## Comments Received during the Public Review Period on the “Inventory of U.S. Greenhouse Gas Emissions and Sinks: 1990-2010.”

Figure 1 – Williams Flowback Data

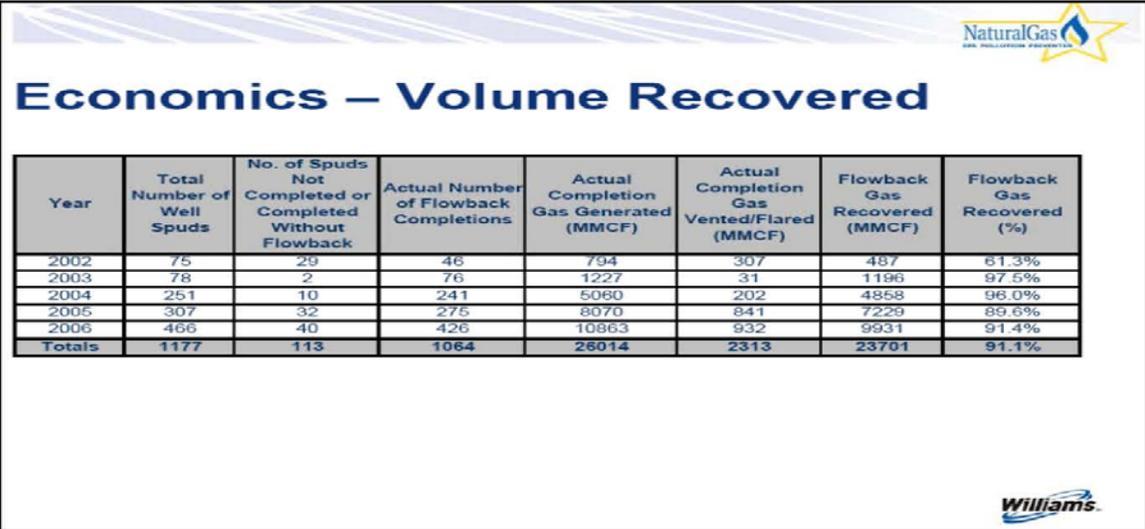
*As noted above, EPA first computes the uncontrolled emissions and then backs out the voluntary and mandatory reductions through a very opaque process. EPA should employ all available data, including the data that will be submitted by companies as part of compliance with Subpart W reporting rules, to develop appropriate emission factors. Some of the revisions in estimation methodologies instituted by the EPA in 2009 were in response to the fact that once Natural Gas STAR Partner reported reductions are subtracted, it suggested that emissions from these emission sources are negative. While we welcome improvements in emissions estimates, it is unclear why EPA ignores reduction data when both the uncontrolled and controlled emissions are available. An example of such a situation is the EPA's derivation of an emission factor for well completions and workovers. The EPA analysis takes the simple average of four sets<sup>9</sup> of completion flowbacks for the unconventional well completion emission factor: 9,175 Mcf/completion. As noted in El Paso's comments on the DRAFT inventory submitted on March 23, 2011, the majority of data for the above EPA factors came from Williams<sup>10</sup> and completion factor was rounded up by the EPA to 20,000 Mcf of natural gas per well. The relevant portion of the presentation is reproduced in Figure 1.*

**Figure 3: Histogram of El Paso Pipeline Group (EPPG) 2011 Transmission Station Reciprocating Compressor Fugitive Emissions in MSCF/YR**

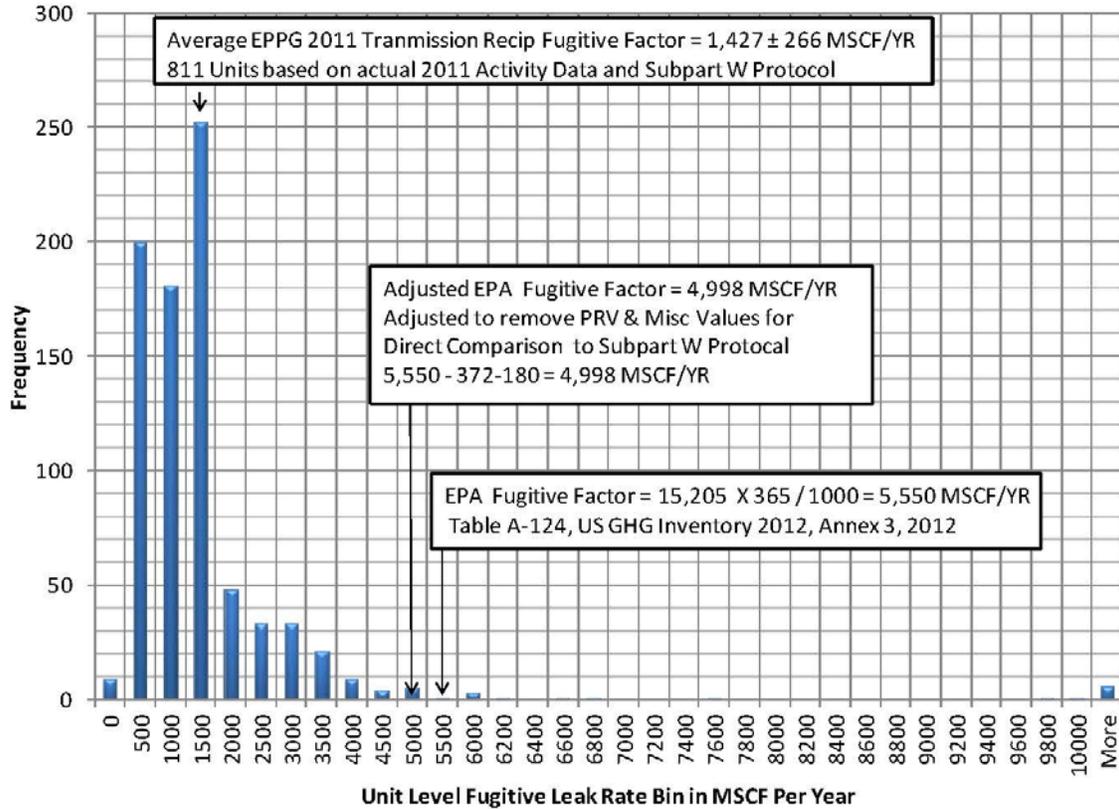
Figure 3 is a histogram that depicts the El Paso the “unit level” emission rates from the above source category using data measured and calculated at 811 units (reciprocating compressor engines) using the EPA Subpart W protocol. The calculated unit level leak rate distribution clearly shows that El Paso compressor fugitives for this source category are significantly lower than EPA’s estimates and there are only a handful of compressor fugitive emission rates (from a unit population size of 811) that exceeded the EPA factor.

**Figure 4: Histogram of El Paso Pipeline Group (EPPG) 2011 Storage Station Reciprocating Compressor Fugitive Emissions in MSCF/YR**

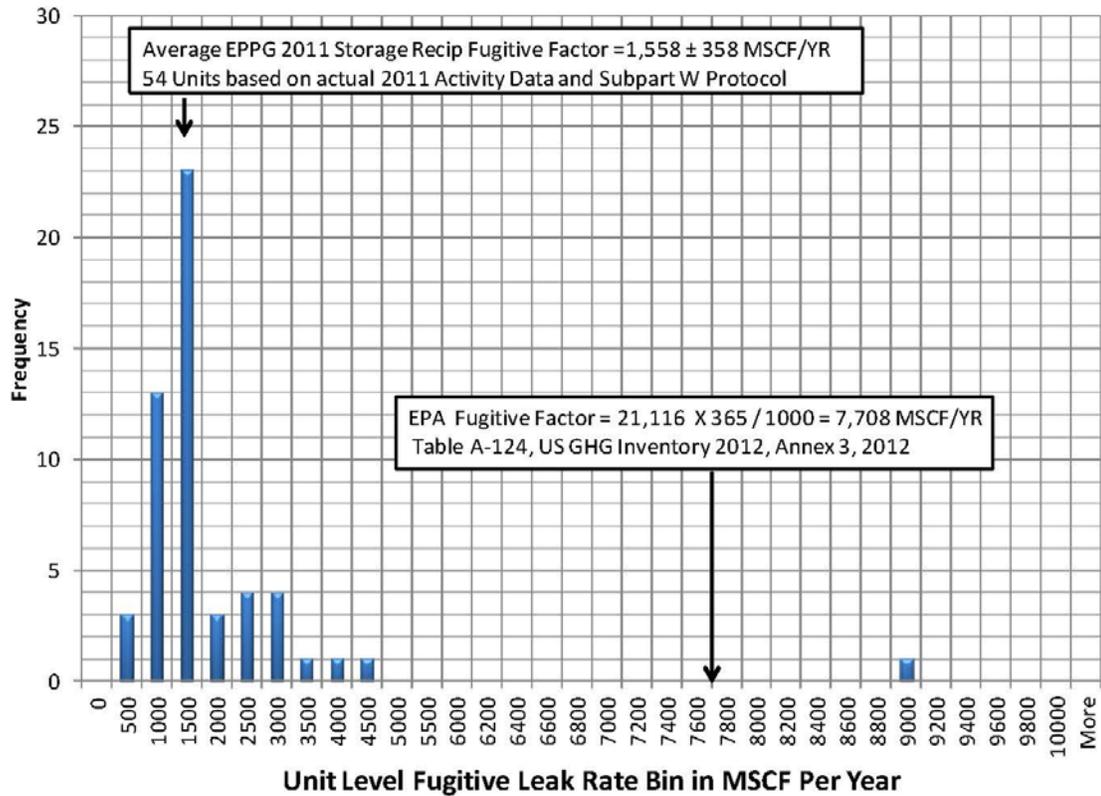
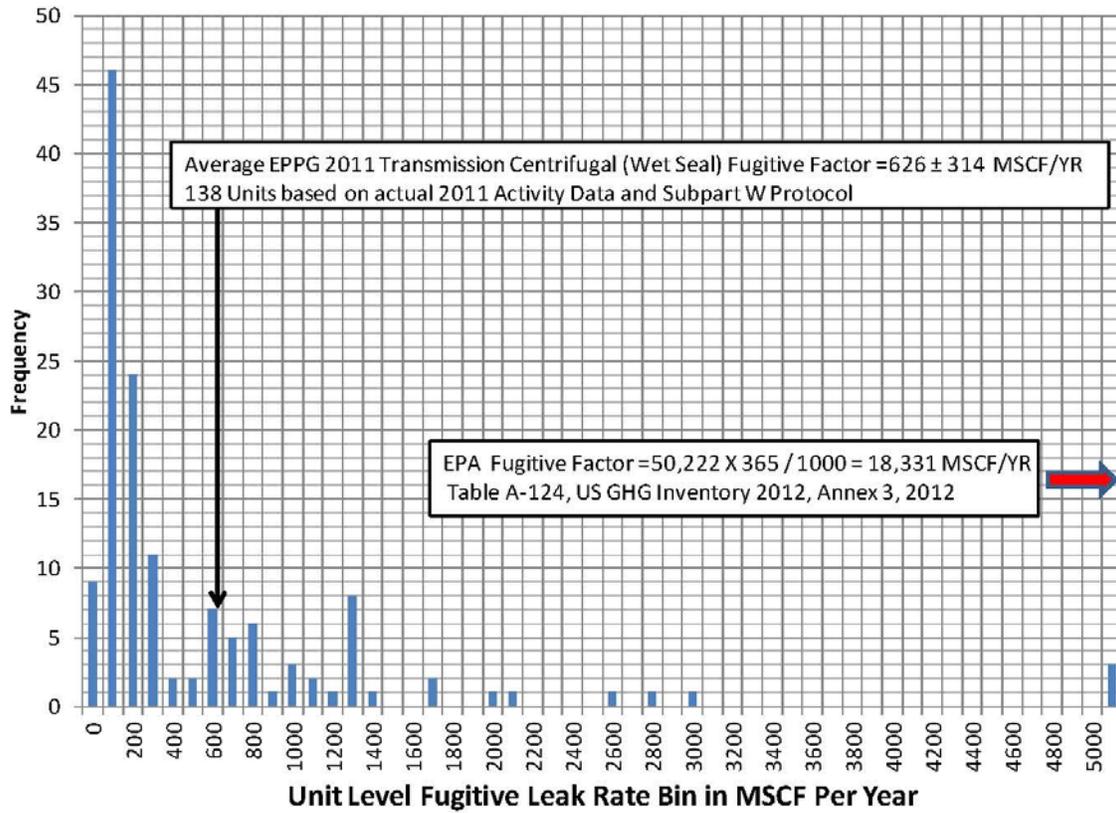
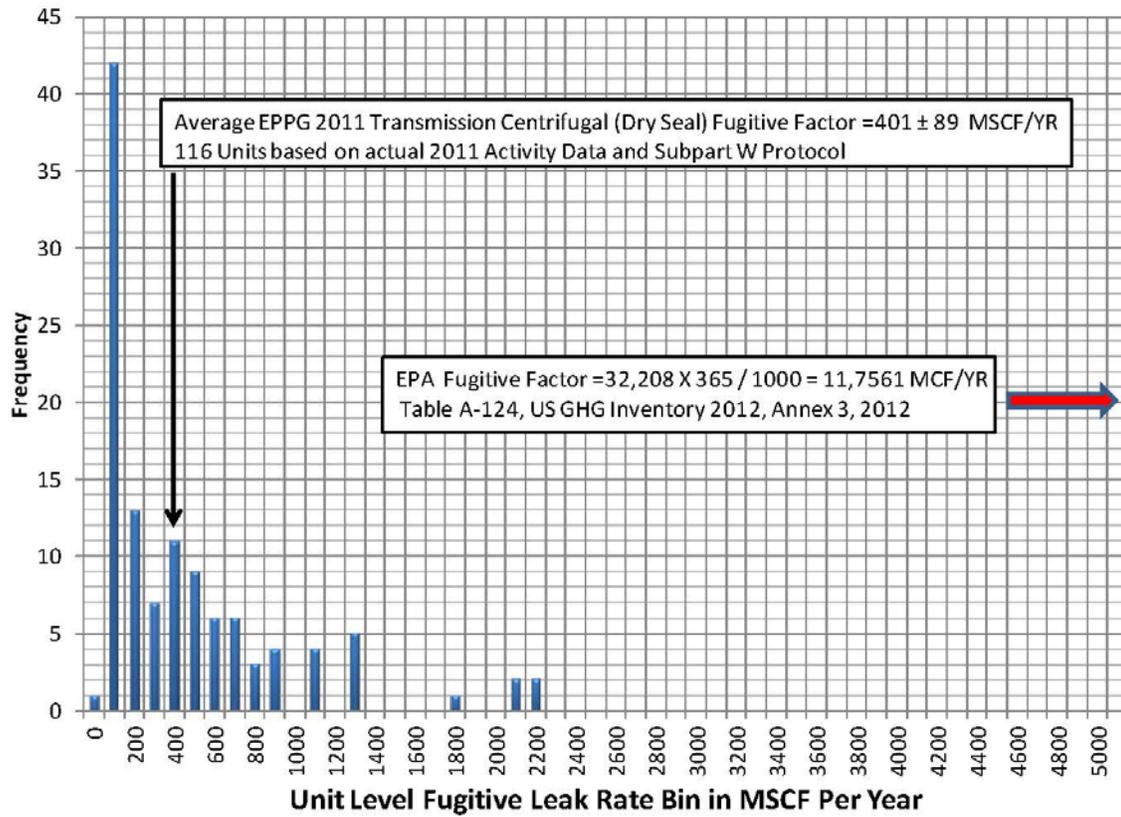
Similarly, Figures 4, 5 and 6 are histograms of El Paso’s calculated unit values versus EPA’s unit level factors for compressor station fugitives (storage), centrifugal compressor station (wet seal) and centrifugal compressor station (dry seal). As noted above (with reciprocating compressor station fugitives), the summary data is presented in Table 3-1. In all cases, the measured value from El Paso results in significantly lower emissions than the factors employed by the EPA. It should also be noted that the El Paso sample size is statistically much more significant than the EPA sample size and unlike some EPA factors is not a linear interpolated or assumed value.
